# Attachment 2 | Summary of Public Comments

## October 6, 2016 National Capital Planning Commission Meeting

SUBJECT: P7713 National Capital Planning Commission, Washington, DC – Squares 378 and 379, 935 Pennsylvania Avenue, NW, Washington, DC – Draft Square Guidelines

L'ENFANT STREET STUDY  
EXTANT STREETS AND REMOVED SEGMENTS

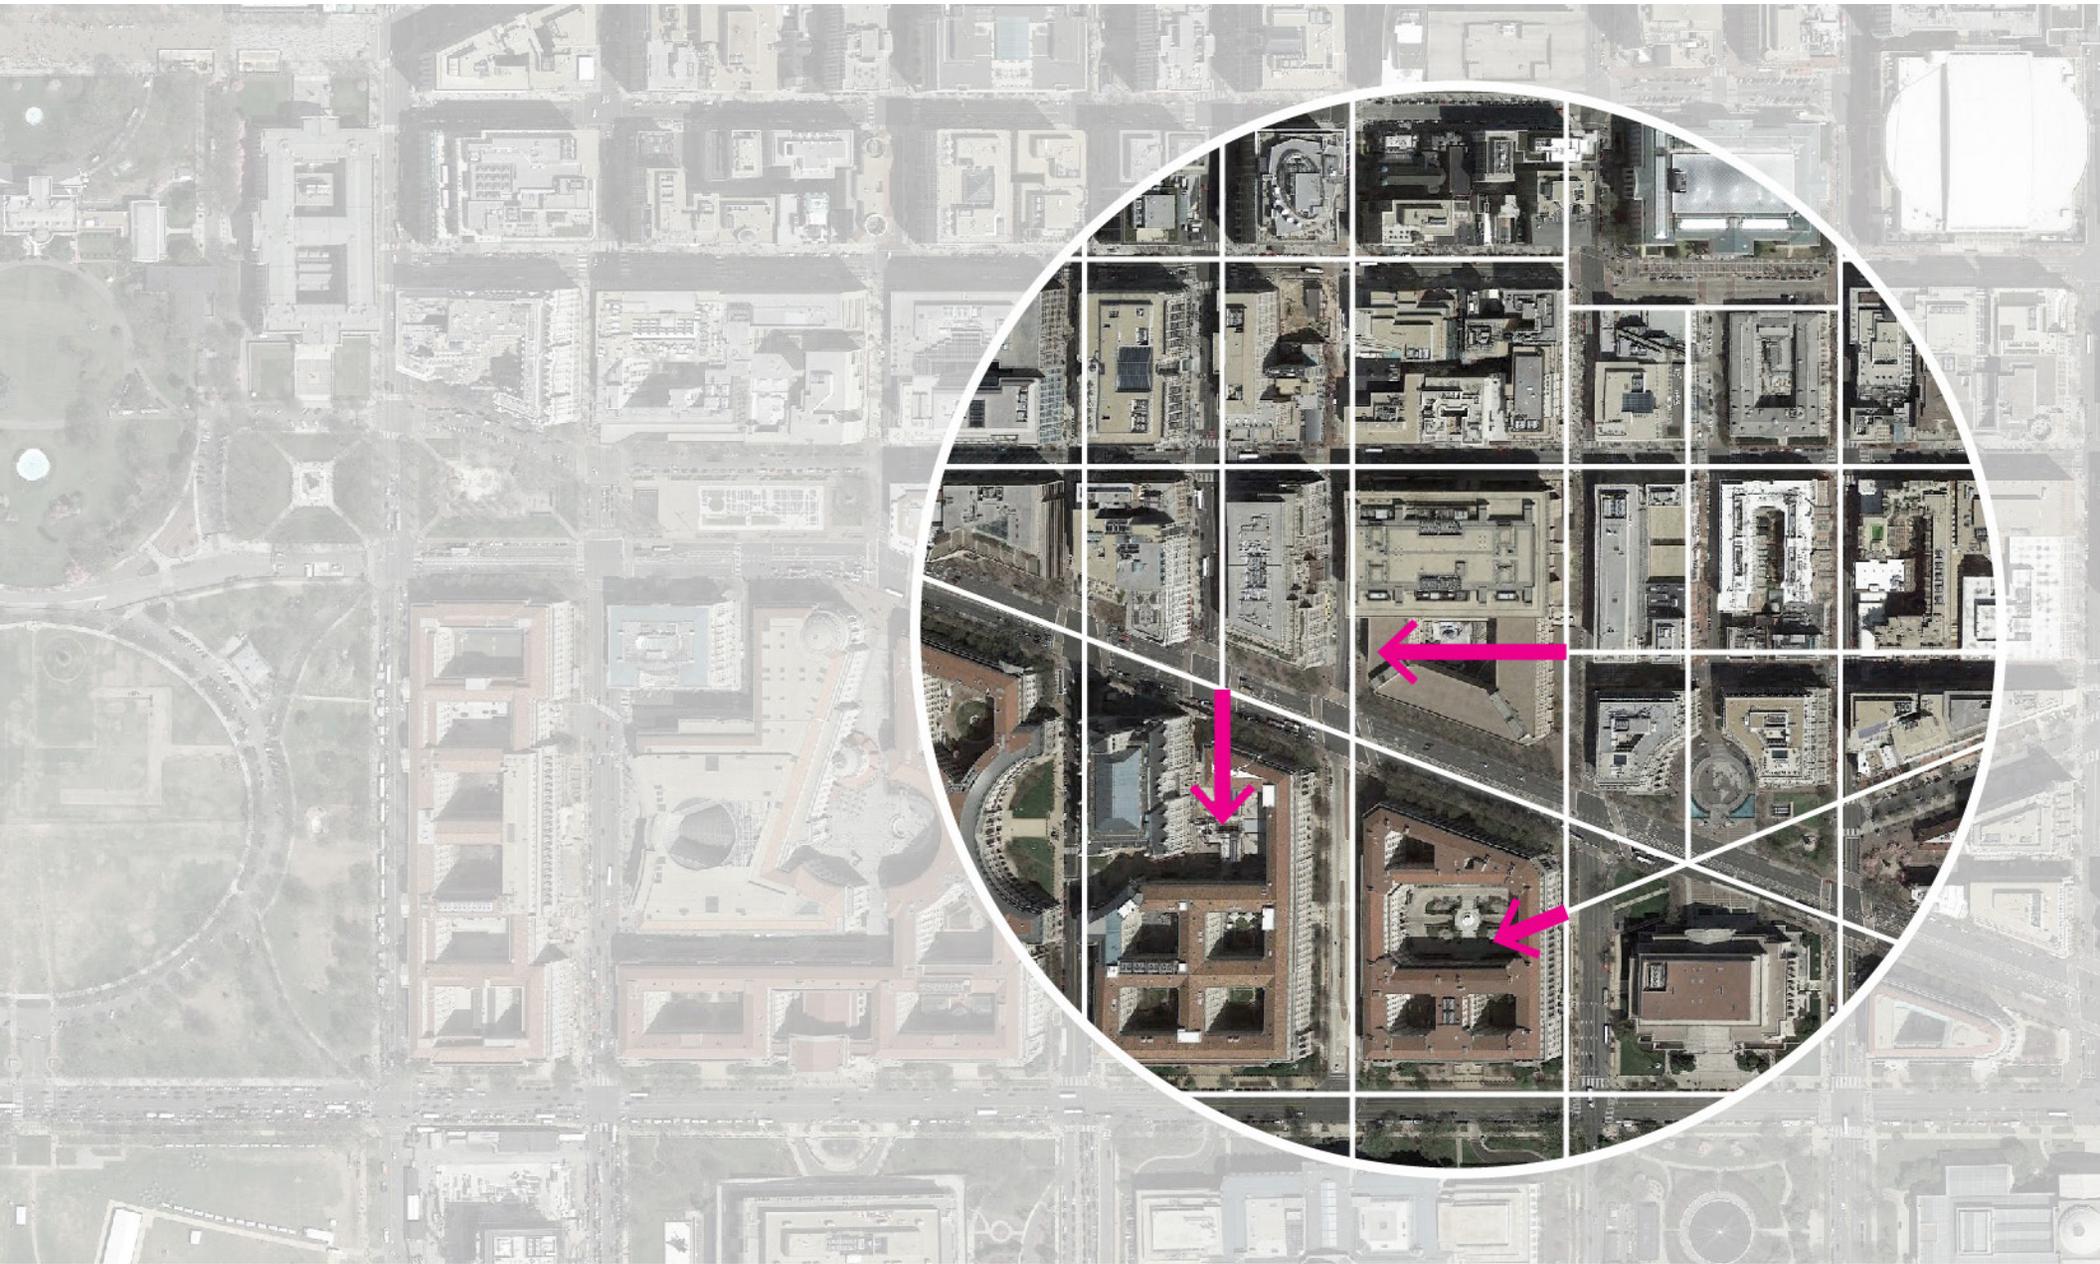
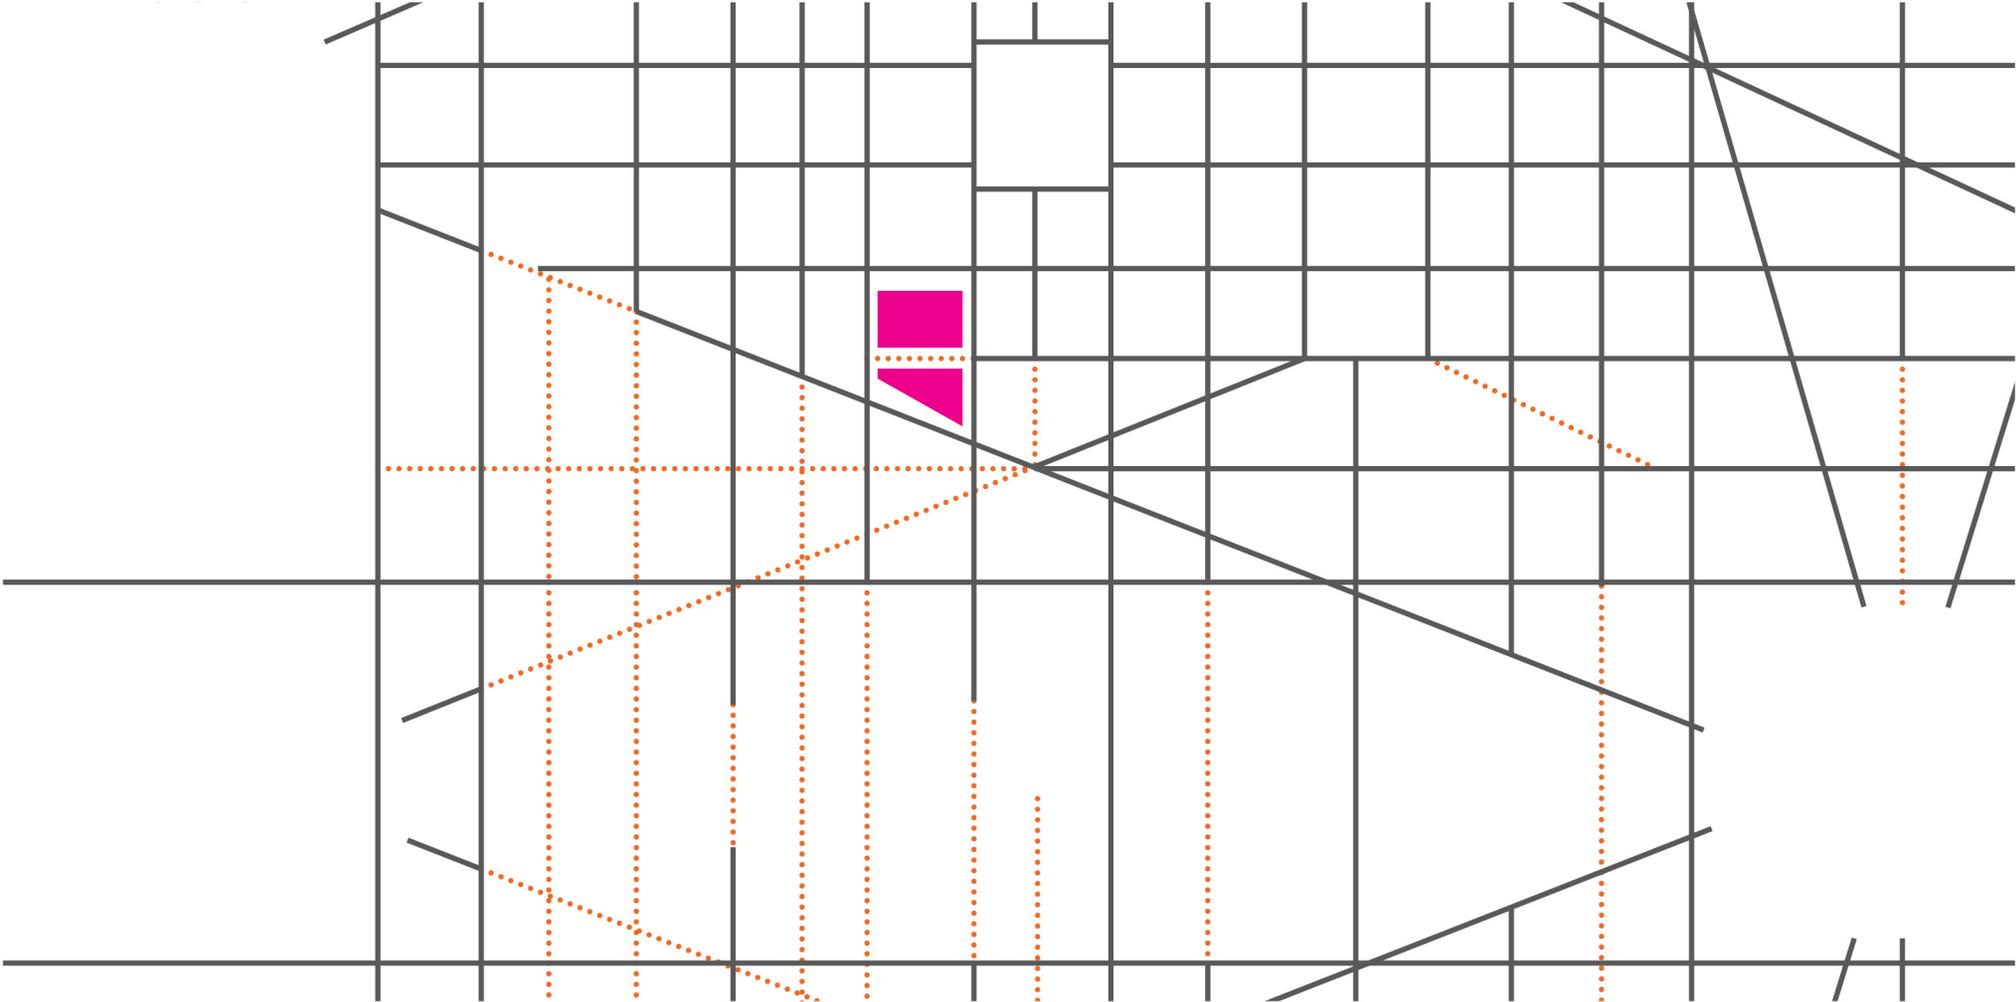
- Looking beyond the site, a full restoration of the former D Street would not restore the true L'Enfant vista to Pennsylvania Avenue since the existing building on the west side of 10<sup>th</sup> Street extends beyond the original L'Enfant Plan. Please refer to the attached diagrams outlining this condition.

- Therefore, D Street should only be restored as a pedestrian easement, and not necessarily a recorded public street. This pedestrian connection would provide the opportunity for the creation of an interior street frontage that can be designed and programmed to create a sense of destination and arrival.
